**Plan Commission Staff Report**  
**Meeting Date: May 20, 2025**

**PETITION:** PC-25-014, Creekside Primary Plat

**REQUEST:** Petitioner requests approval of a Primary Plat for 156 units/lots and one (1) block on +/- 91 acres.

## Exhibit A – Areas A and B

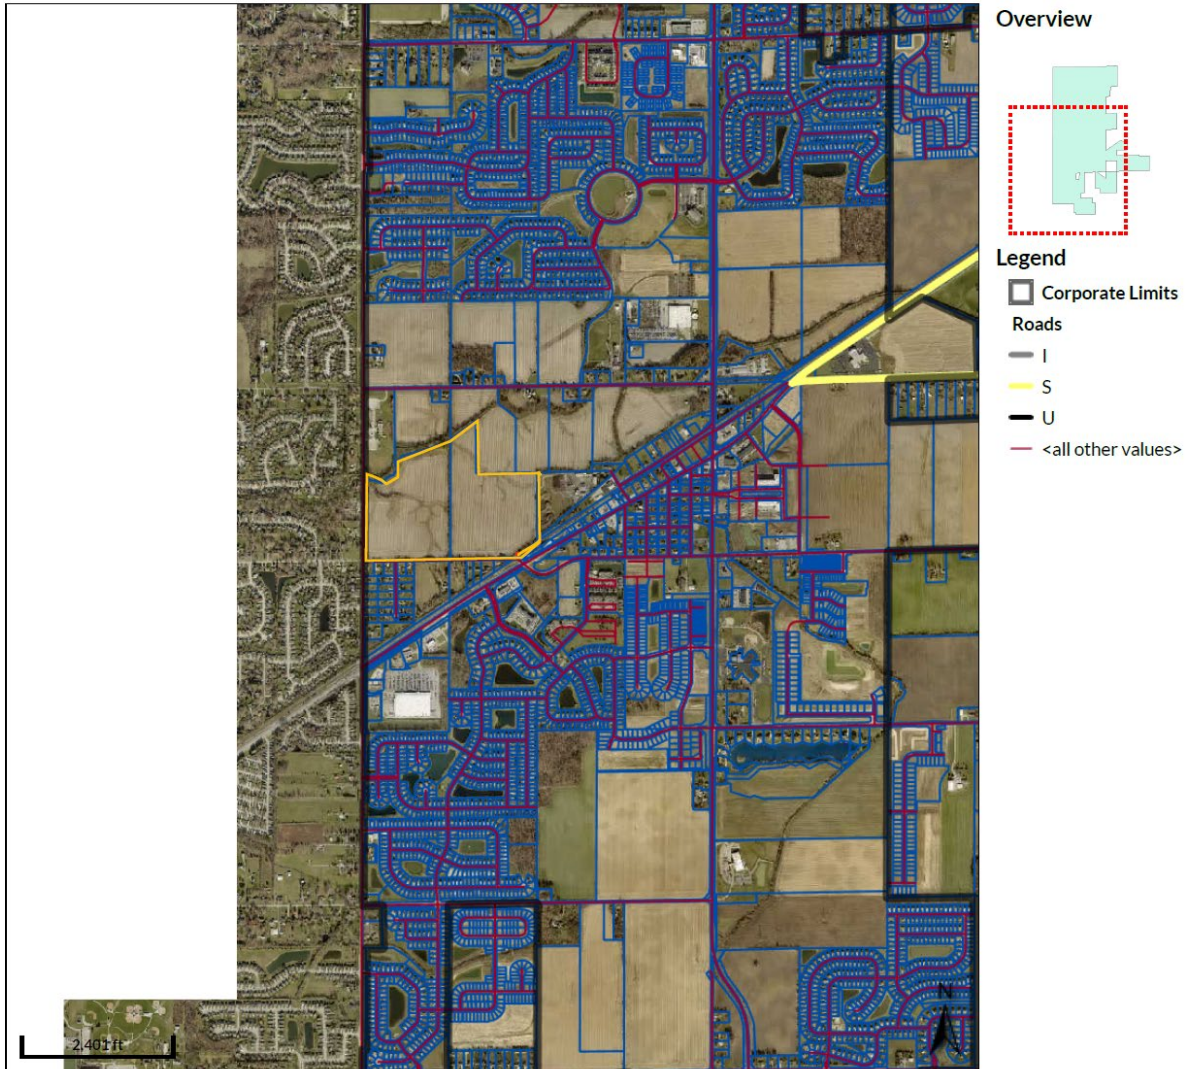
1. Staff has requested the grass strip between the curb and sidewalk on Harlan Run Drive be 10' wide from CR 750N to Morris Creek Lane. The current plans only show this to McCray Run Drive.
2. The secondary front yard setbacks (for corner lots) have not been denoted on the site data tables on the cover sheet.
